Service Bulletin

Bulletin No. 2004-05R1

Gen II Cool Fuel Pump Replaced by Pump / Cooler Kits

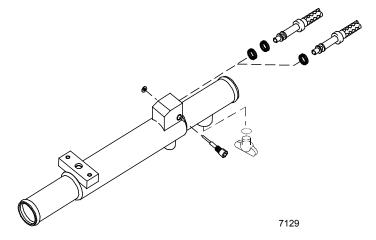
The fuel pump for the Gen II Cool Fuel System is no longer available as an individual component. The pump will now be available only as part of a Pump and Cooler Kit, which includes the fuel pump, fuel cooler, and hardware. Three kits will be available, and the applications for each kit are described below.

The various coolers are not interchangeable, therefore, be sure to order the correct kit for the model and serial number of the engine being repaired.

861156A02 - Fuel Pump / Cooler Kit With Drain - has fuel cooler (861267), which has an integral water drain port and has a cross bolt to retain the fuel line to the fuel cooler outlet

861156A03 - Fuel Pump / Cooler Kit Without Drain - has fuel cooler (865356), which is shorter, does not have a water drain port, and has a cross bolt to retain the fuel line to the fuel cooler outlet

861156A04 - Fuel Pump / Cooler Kit With Drain - has fuel cooler (807950), which has an integral water drain port and has a fuel line retaining bolt that is parallel to the fuel line to attach the fuel line to the fuel cooler outlet
